## Technical Brief

**Subject: Summary of Changes since Conceptual design review on February 17 2022**

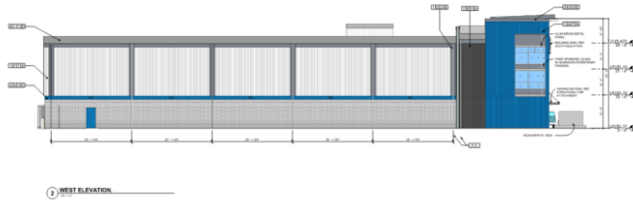
Site Plan and Overall Site Plan to match areas shown on Preliminary Grading and Preliminary Landscape Plans as well. Monica, please review and correct the civil plan or advise if arch plan need to be changed.

Original concept revised concept West elevation

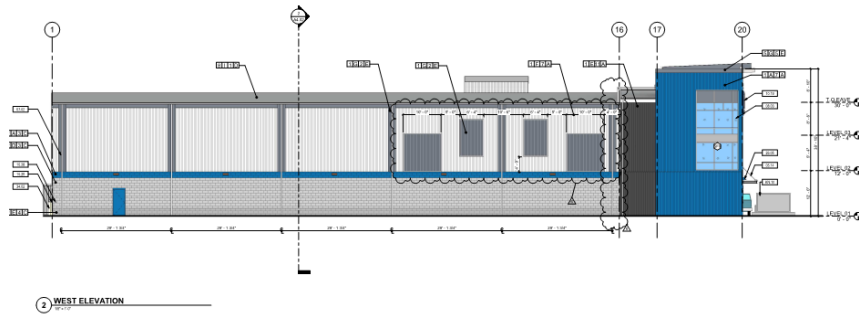
- Revised building elements on front façade to improve building language and design.
